Perry Nuclear Power Plant  
Docket No. 50-440, License No. NPF-58Response to Request for Additional Information Regarding Request for Licensing Action  
on Alternative Accident Source Term Radiological Dose Calculations (TAC No. MF3197)

Attachment 1: Response to Request for Additional Information on Dose Calculations  
Attachment 2: Summary of Calculation Addendum - Technical Support Center X/Q and Dose  
Attachment 3: Electronic File of Meteorological Data on Compact Disc

Response to Request for Additional Information on Dose Calculations  
Page 1 of 12

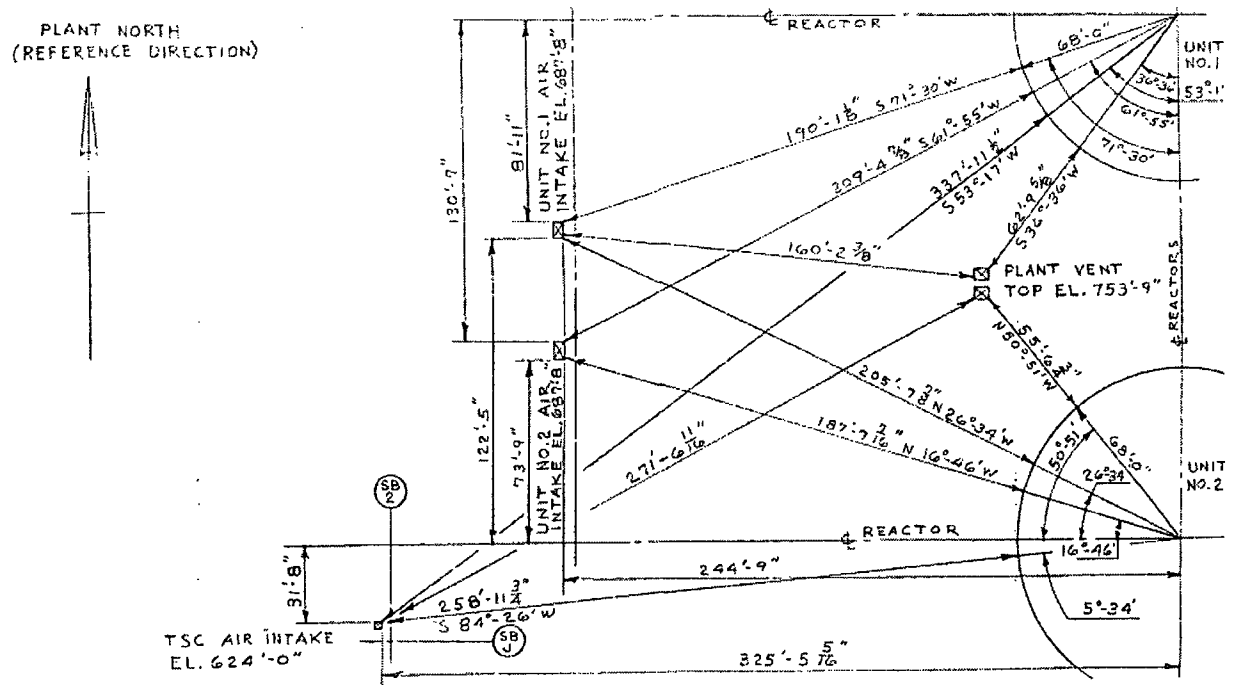
**b. Scaled drawings showing the locations and heights of the release points for the LOCA and for the MSLBOC accident, the TSC and CR intake locations and heights, distances between the release points (sources) and receptors, and orientations relative to True North from the receptors to the sources, and from which building heights and dimensions can be determined; and**

Also see USAR Figure 12.3-9 Radiation Zone, Section A-A, and the following two sketches:
